Staff Report

Re: Detached Accessory Dwelling Unit – Conditional Use (PLNPCM2020-00155)

PROPERTY ADDRESS: 2496 South 1700 East

G001

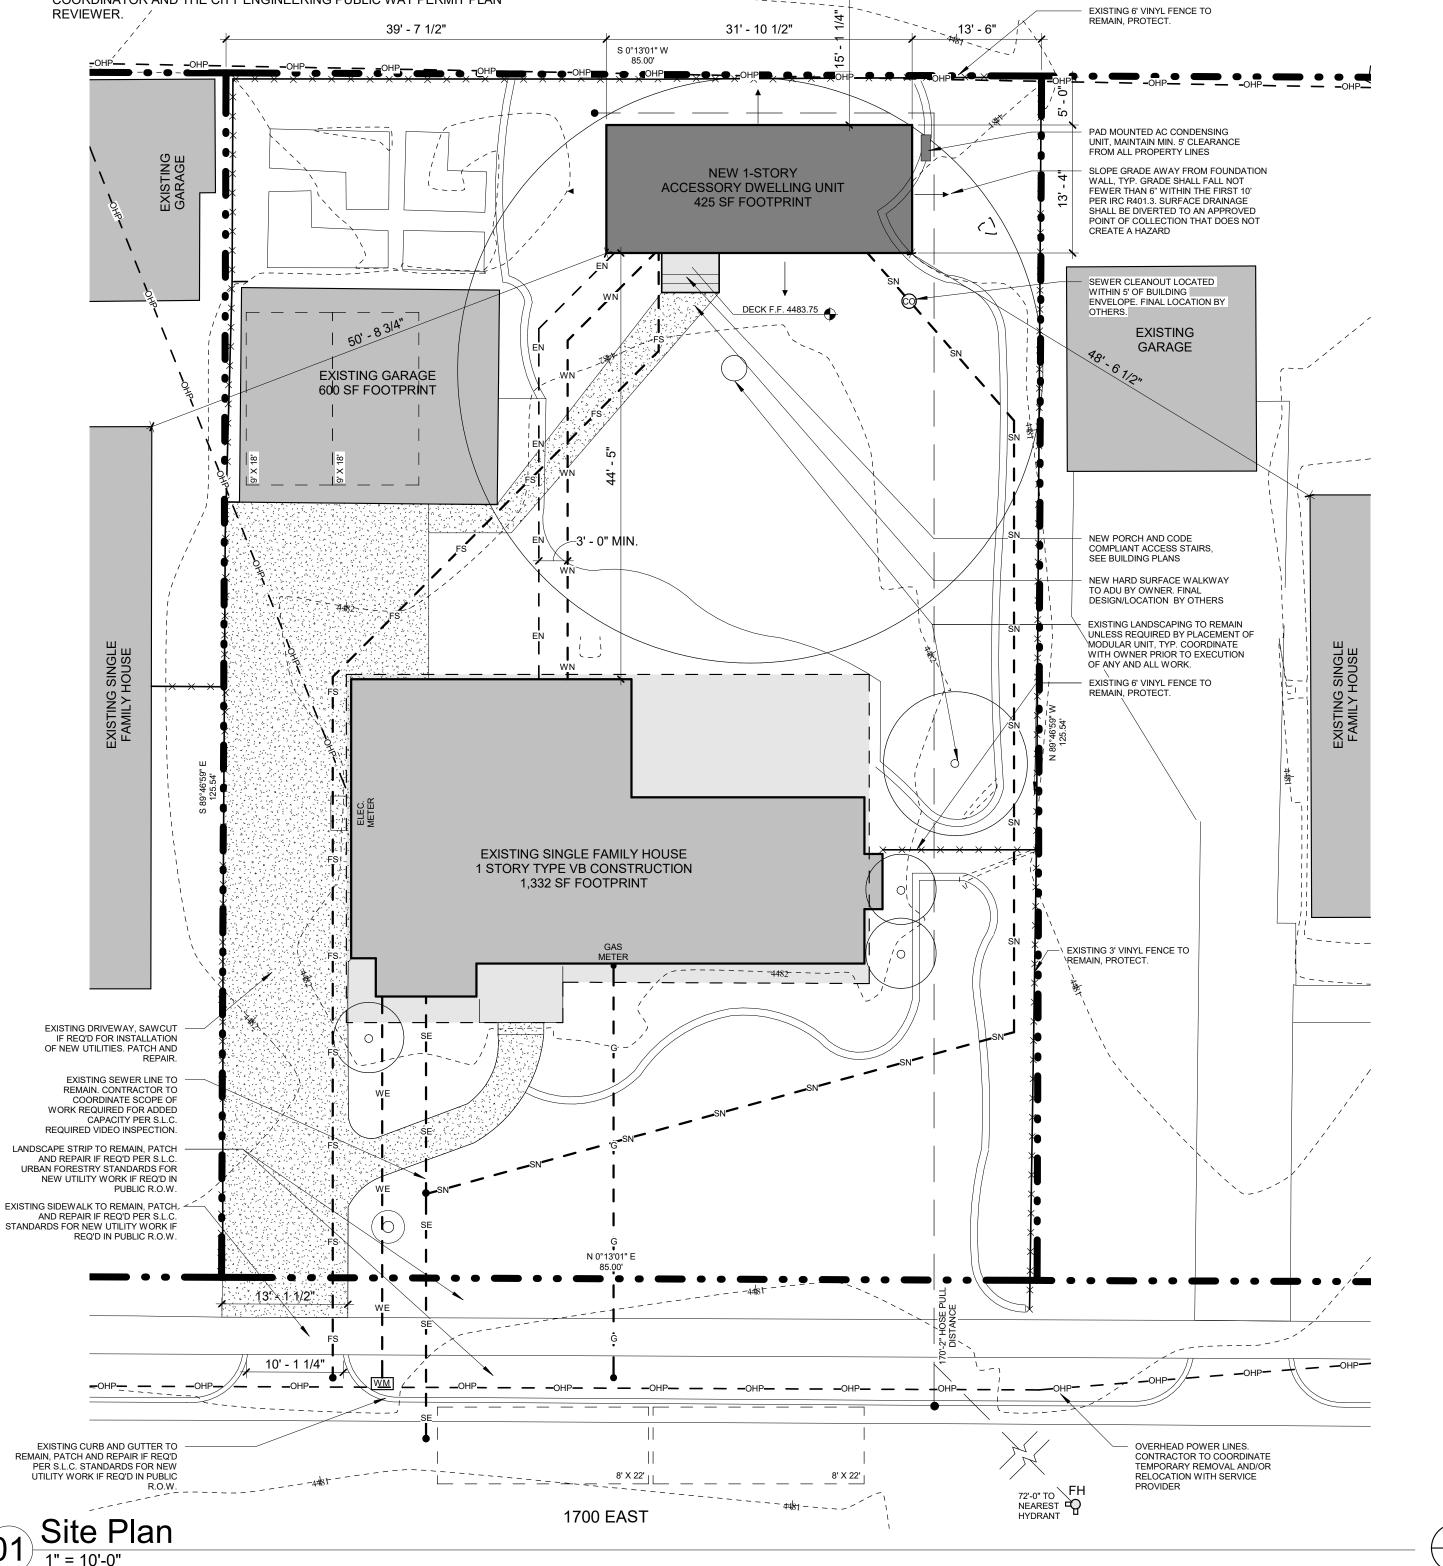
This lot appears larger than the others we are reviewing, although the graphic we were given is so blurry it is impossible to know how big the lot is and what the lot coverage is in the rear yard. People feel like this is going to ruin their neighborhood, and that is sad.
